Access Compliance Report Public Rights-of-Way (Curb Ramps)

Main Street: EPONA_WAY		Cross Street: EPONA_WAY		Location:	W
ADA ID: RPRK211103155422	Ramp Type:Type 1 - Perpendicular	Initial Pass/Fail: Pass	Overall Compliance: No	Severity Score:	15

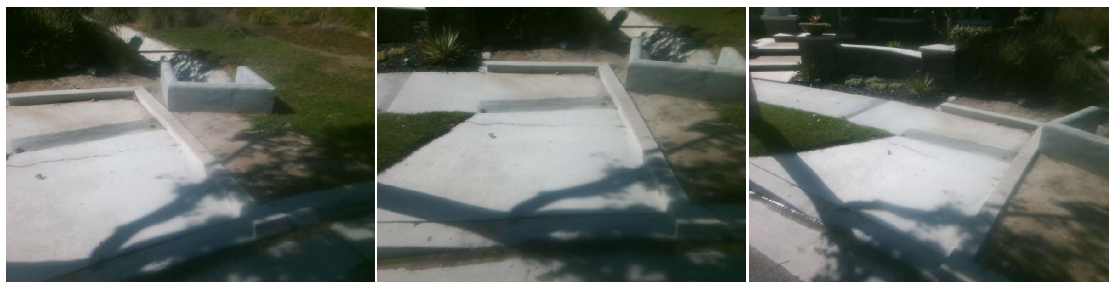
R304.2.2, R304.2.1, R305, R304.5.4, STD 1115

Remove & Replace Entire Ramp. Remove & Replace Gutter.
